2008 AEC-NRC Bilateral Technical Meeting

Status of Lungmen FSAR Review with Emphasis on Transient and Accident Analysis

May 12-13, 2008

Institute of Nuclear Energy Research

LOCA

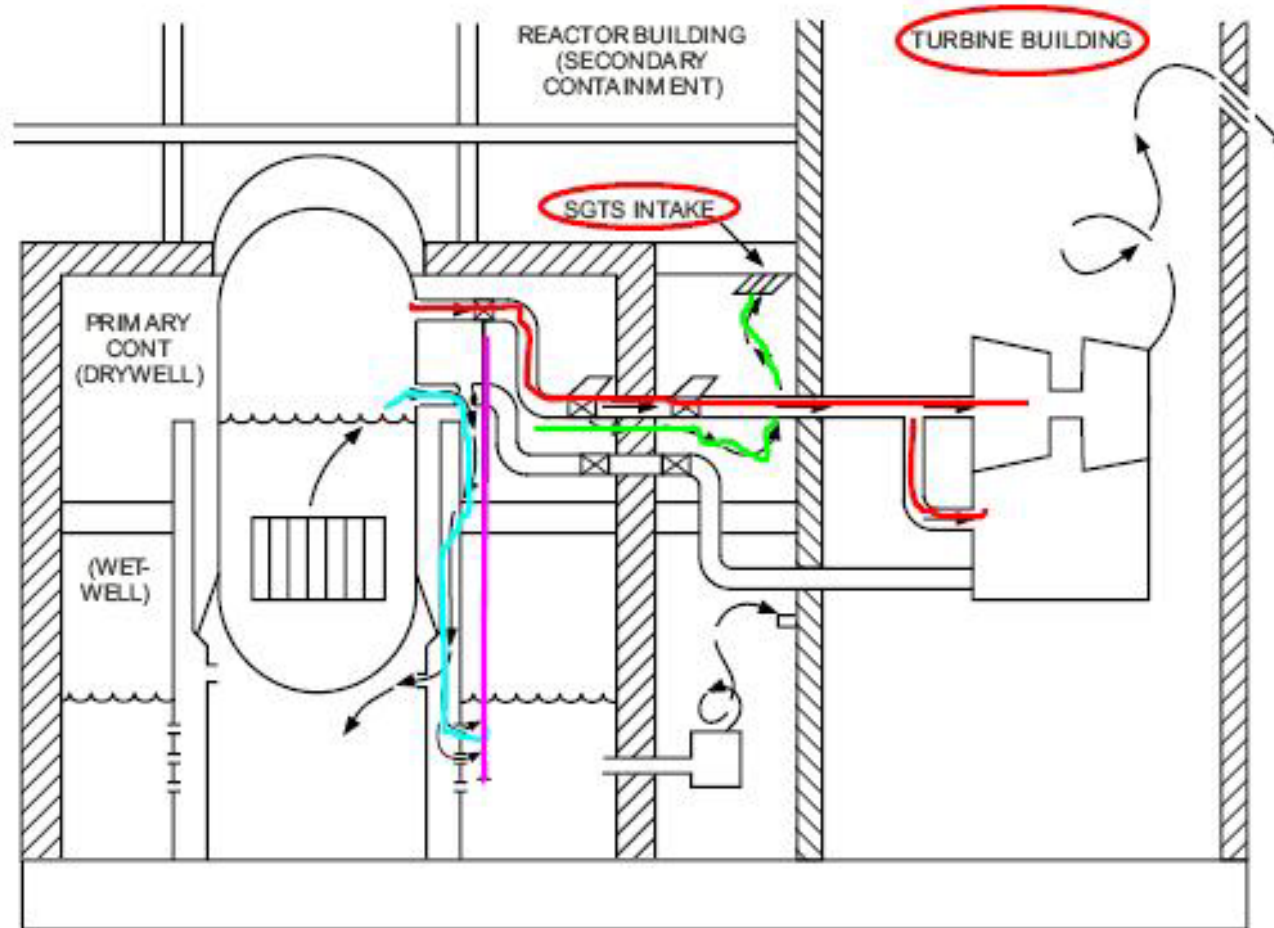
- No fuel damage resulted from this accident
 - Peak Cladding Temperature is no longer one of the most important issues
- Radiological Consequences
 - Small LPZ
 - Radiological Consequences of LOCA become one of the most important issues
- Containment Design Limit
